The National Board of Boiler and Pressure Vessel Inspectors

May 12, 1982

SUBJECT: National Board Audit as Requested by the State of Ohio, Division of Boiler Inspection, of the ASME Code Related Construction of the William H. Zimmer Nuclear Power Plant, Moscow, Ohio

INTERIM REPORT

SHEET 2 OF 2

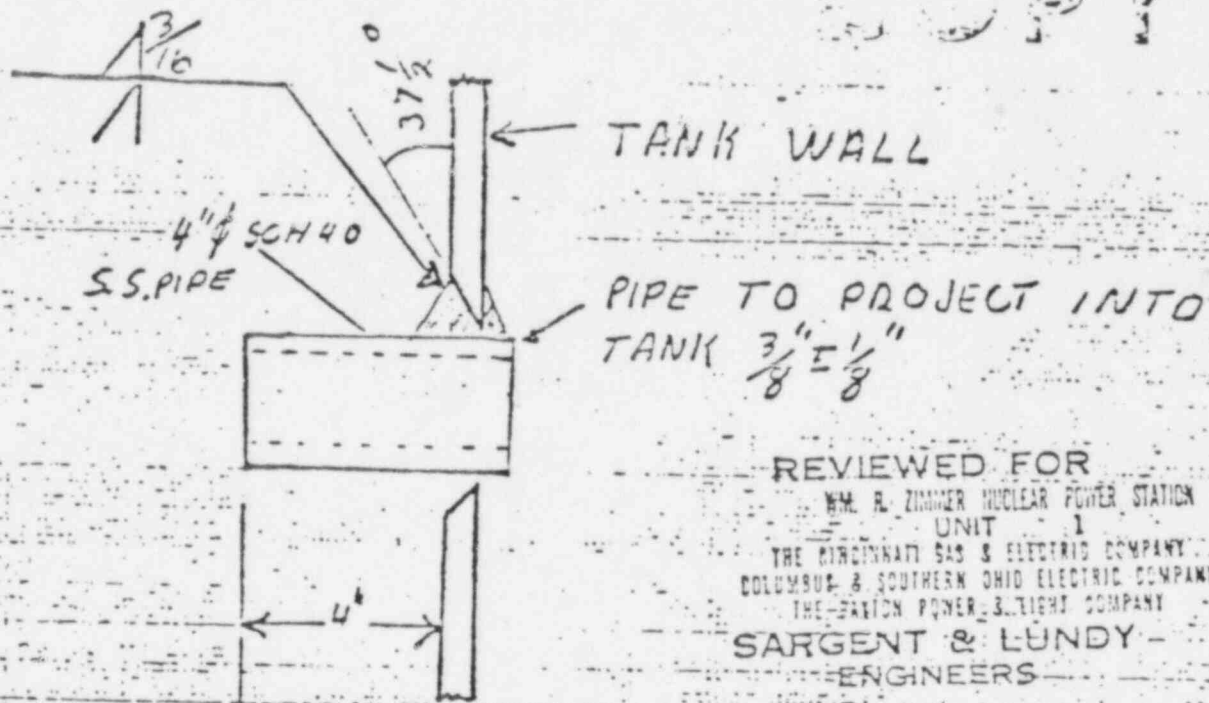
Revision 2 to the FDDR would have required boring the I.D. of the pipe. This is difficult to perform per the constructor. Therefore, the revised design proposed is per this FDDR KN-1-1012 Rev. 3 Sheet 2.

Engineering is to advise acceptability of the revised nozzle detail per sheet 2.

I ALL PORTIONS OF FDDR-KN-1-1012 REV 1
REMAIN UNCHANGED EXCEPT FOR PAGE 10
AS NOTED BELOW.

II DELETE ITEMS 3, 4 & 5 ON PAGE 10 OF
FDDR-KN-1-1012-REV 2
